1984 Corvette: Service Bulletin: No Heat - A/C Control Unit

Source: Chevrolet Dealer Service Technical Bulletin

Bulletin Number: 83-T-70, Number Ia

Date: August, 1983

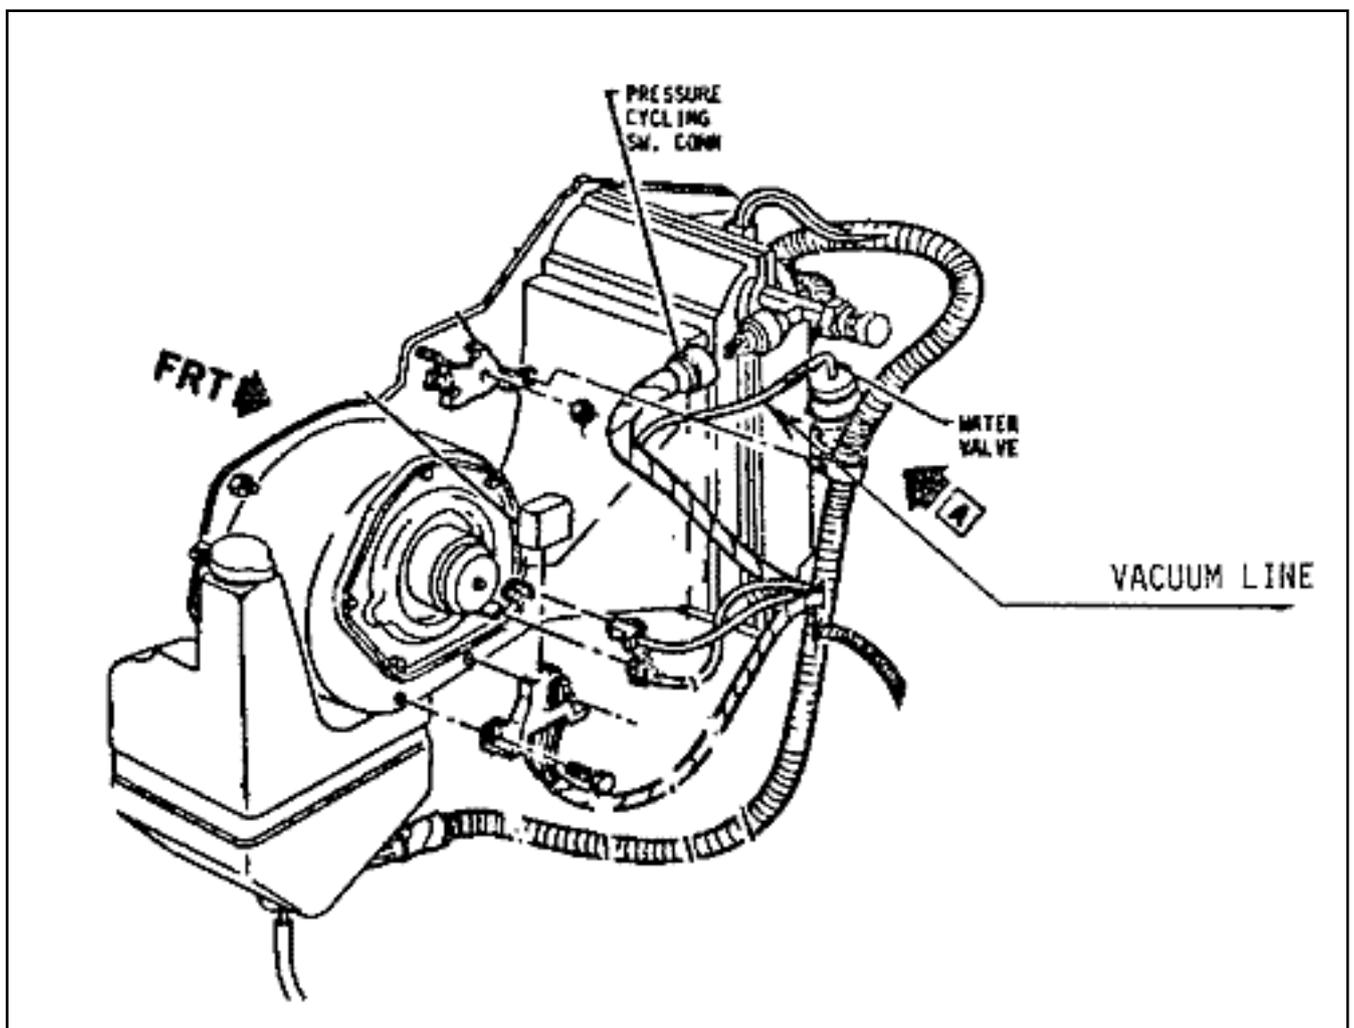
The vacuum switch in the A/C control unit controls a water shut off valve on the evaporator blower assembly. This valve should be closed with the temperature selector lever in the full cold position and open with the lever in any other position. Water will not flow through the heater core when the valve is closed (vacuum applied). Note that the valve actuating rod will be extended when the valve is open and retracted when closed (refer to sketch).

Vehicles built after April, 1983 have incorporated a revised A/C control unit.

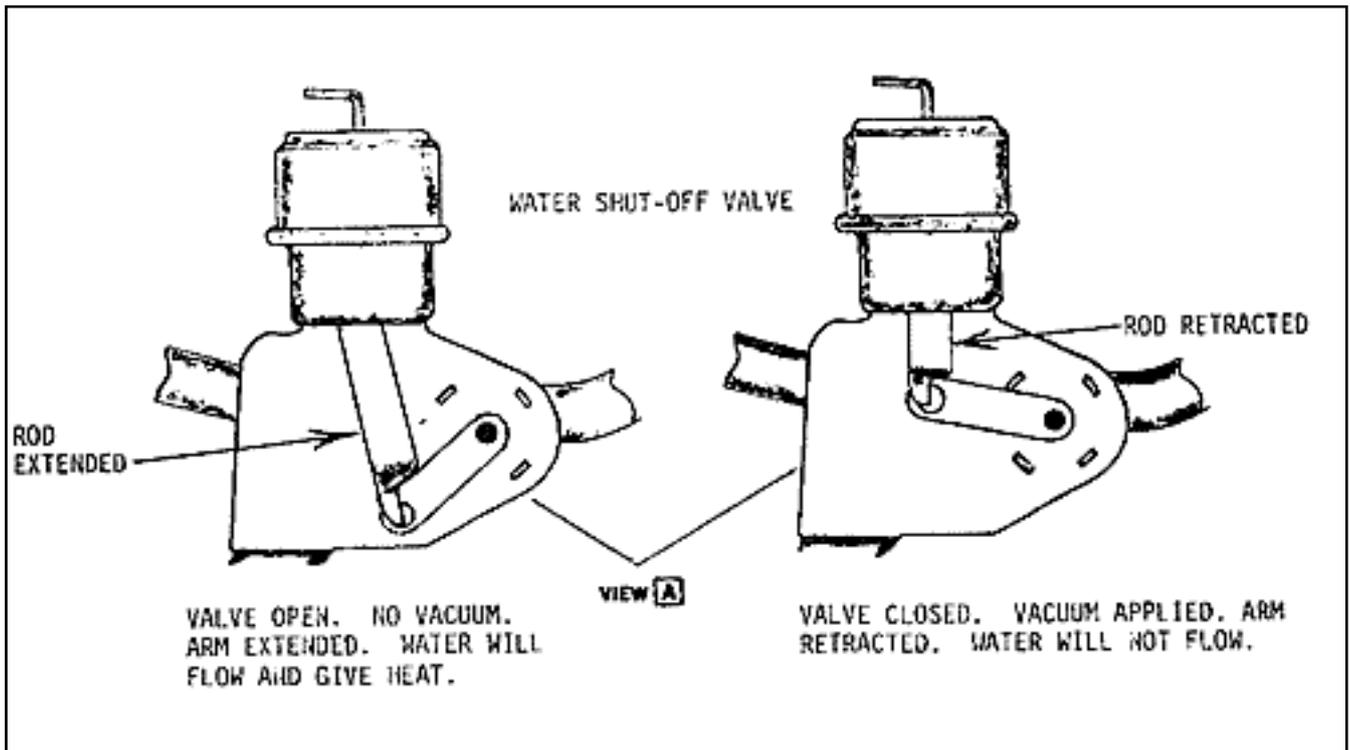
On vehicles, built prior to April, 1983, the following procedure is recommended to resolve this "no heat" condition:

1. Observe the operation of the valve on the blower assembly while the temperature selector lever is moved from "cold" to "hot" position. The engine must be running to supply vacuum and should be at operating temperature.
2. If the valve opens (rod extended) when the temperature selector lever is moved to the "hot" position and heat output does not occur, the condition is not directly related to this particular control unit problem and should be further diagnosed, as described in Chevrolet Service Manual, Section 1.

3. If the valve does not open (rod retracted) remove the vacuum line from the valve. If this causes the valve to open and results in heat output, refer to Step 4.

4. Leave the vacuum line off the valve and seal off the end of the line to prevent a vacuum leak. (This can be done by fabricating a rubber plug or equivalent.) Secure the loose line to the harness with a band strap.

5. The vehicle can be operated with this line disconnected from the valve with no adverse effect to the A/C system.
